Redline Appert 20221108

PART NAME OMC DCPD MOUNT ASSEMBLY  
 DESIGNER J.LEWIS 13 NOV 2012 SIZE DWG. NO. B D1201273 REV. v3  
 DRAFTER J.LEWIS 13 NOV 2012  
 CHECKER APPROVAL  
 SCALE: 1:1 PROJECTION: SHEET 1 OF 1

D1201273 OMC DCPD MOUNT ASSEMBLY, PART PDM REV: X-016, DRAWING PDM REV: X-007

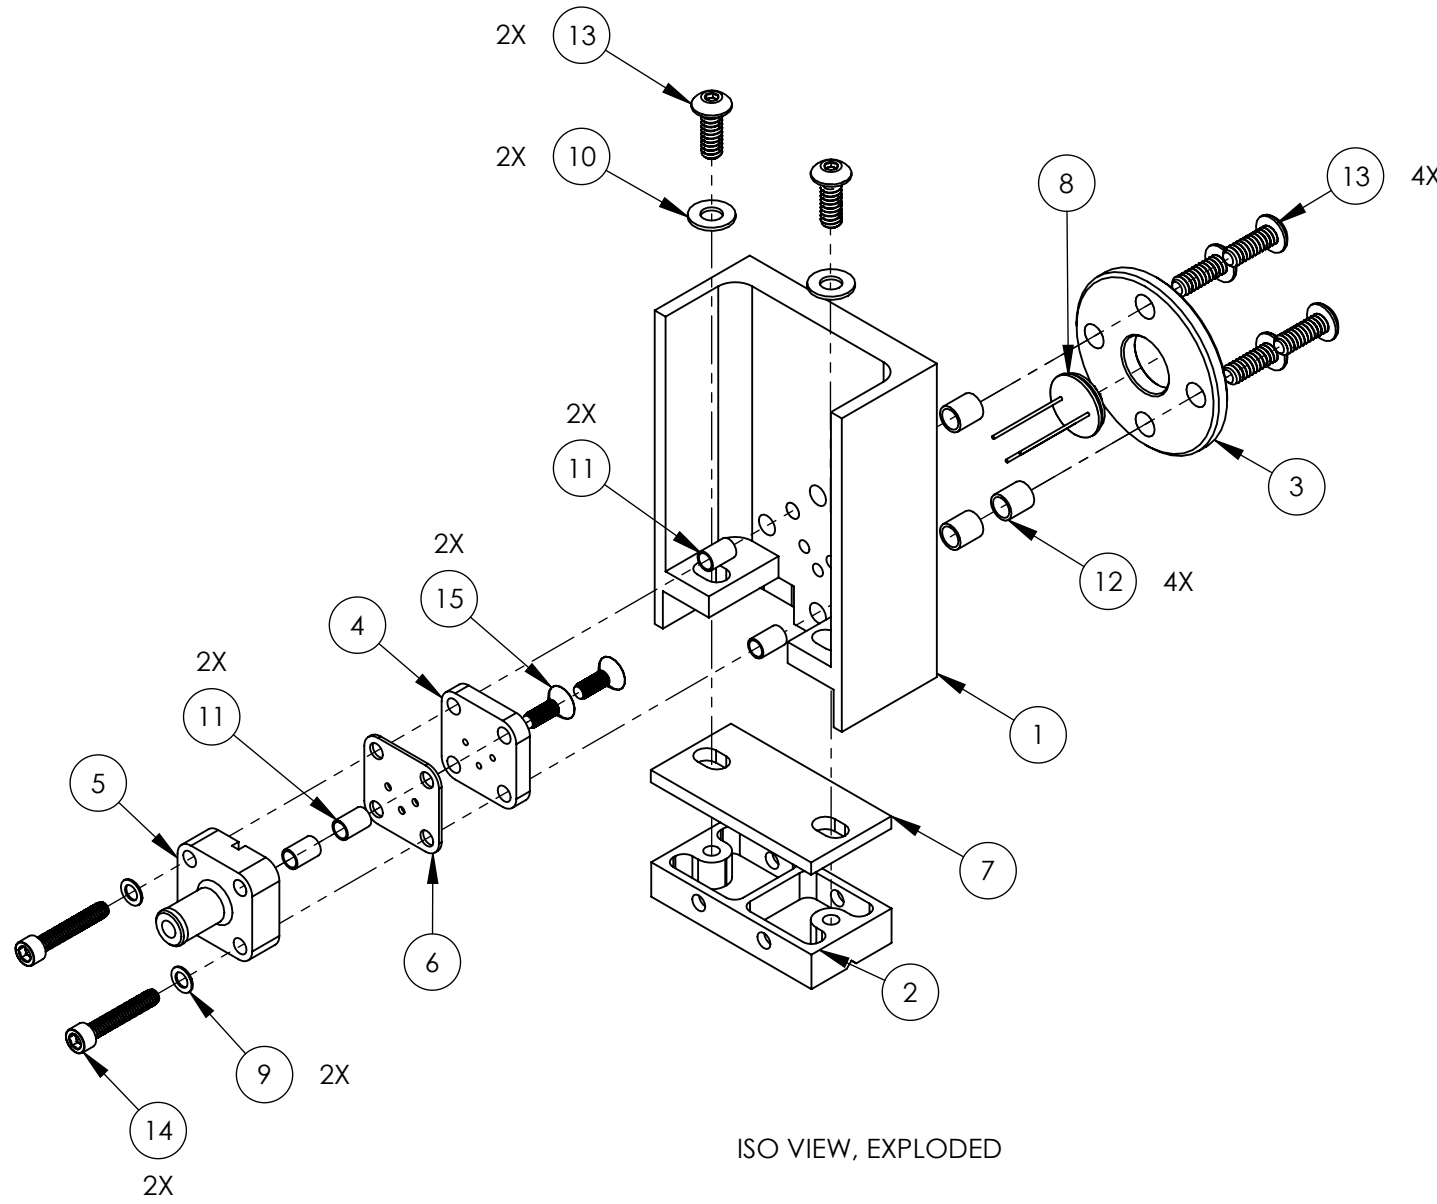
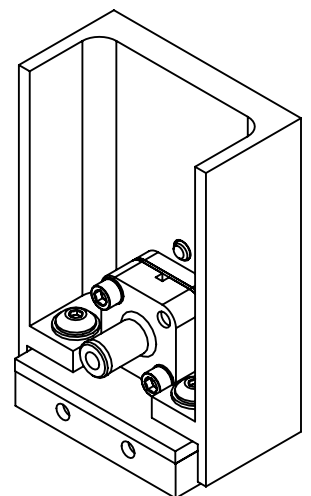
Item 8 p/n  
 FHHL/Laser Components USA, Inc. IHGQEX3000  
 (CAD geometry can be the same)
